SITE CONTEXT PLAN

URBAN DESIGN PANEL MINUTES

November 29, 2000

2. Address:	5438 Rupert Street (3014 Kingsway)
DA:	405240
Use:	Mixed Use
Zoning:	C-2
Application Status:	Complete
Architect:	Andrew Cheng
Owner:	Hungston (Rupert) Development Ltd.
Review:	First
Delegation:	Andrew Cheung, Francis Yau, Keith Ross
Staff:	Bob Adair

2014 KINGSBWAY	
Building Elevations	
DATE: 11/14/2013	PROJECT: 2014 KINGSBWAY
DRAWN BY: [Name]	CHECKED BY: [Name]
SCALE: 1/8" = 1'-0"	DATE: 11/14/2013
8

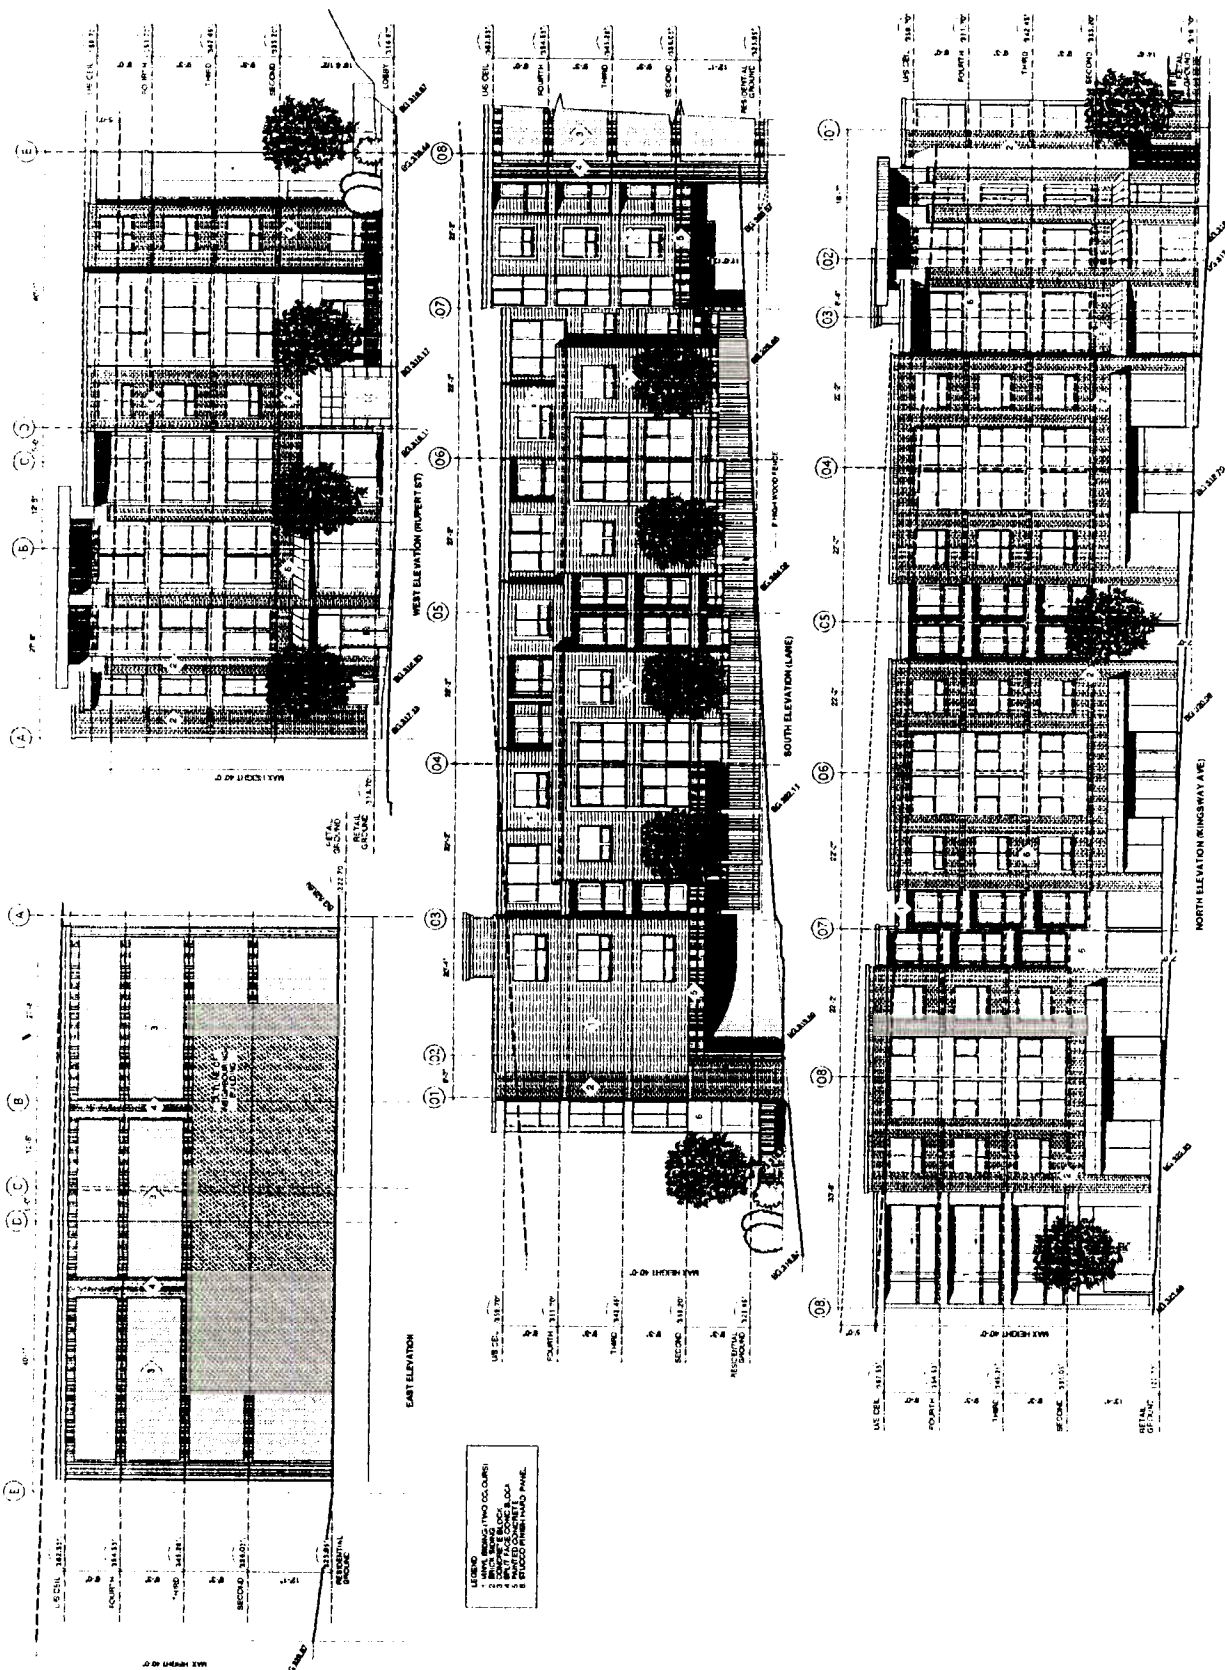
Concerns were expressed about the Kingsway facade and the manner in which the top three floors rest on the plinth of the retail bays. The varying height and thinness of the lintels was questioned. It was suggested it might be better for the three bays to continue down to the ground and establish more of a vertical rhythm along the street. The Kingsway facade has a flatness that needs to be improved upon. The upper level massing on Kingsway, as well as the massing at the rear, was thought to be quite interesting.

The Panel thought more attention needed to be given to the quality of materials and choice of colours. The use of vinyl siding was questioned, particularly the fine grain vinyl indicated. In this high traffic location it will quickly become very dark and dirty. It was felt the colours need to be darker and bolder.

Serious concerns were expressed about treatment of the Kingsway corner which needs to be much more robust. As well, the southwest corner could be improved by building it out to the same footprint as the building above. This would enable the amenity space to be enlarged as well as providing a better anchor for that corner. One Panel member found the whole southern facade very awkward and suggested reorienting the exit stair from the garage towards the west. This would also gain some of the open planter area for the adjacent unit.

In general, the Panel found the material presentation and resolution of the mass - particularly on Kingsway - far too timid. This is a highly visible corner that needs to be emphasized with a strong piece of architecture. This is an area in flux, and this project will set the tone for the future development of neighbouring corners.

- **Panel's Comments:** A Panel Member suggested that the applicant has addressed the Panel's concerns relative to exterior materials and the Kingsway elevation, recognized that the project's height has been minimized, and suggested the portion above 45 feet could be considered an appurtenance. Panel Members recognized general improvements to the project's design, and supported the proposed height. It was suggested the windows could include typical brick detailing above and below to provide character, and suggested the cornice line be enhanced and strengthened.

Most Panel members felt that stepping down of the third bay, closest to the corner, was not necessary. The exterior materials, brick details, and window details were discussed. It was noted that the façade needs a sense of thickness in materiality, more substance and detail. Although the colour is improved, it was suggested that it may be too near to being all brown, and colour variations should be used to reduce the monolithic quality.

- **Applicant's Response:** Mr. Cheung agreed the Panel's comments are very valid. He expressed concern that greater stepping of the floor plan will cause problems in terms of handicap access.

- **Applicant's Response:** Mr. Yau suggested that the colours may not be clearly interpreted in the drawings displayed, and noted that the rendering also doesn't clearly indicate the building's window setbacks, and balcony setbacks. Comments and suggestions of the Panel were acknowledged.
-
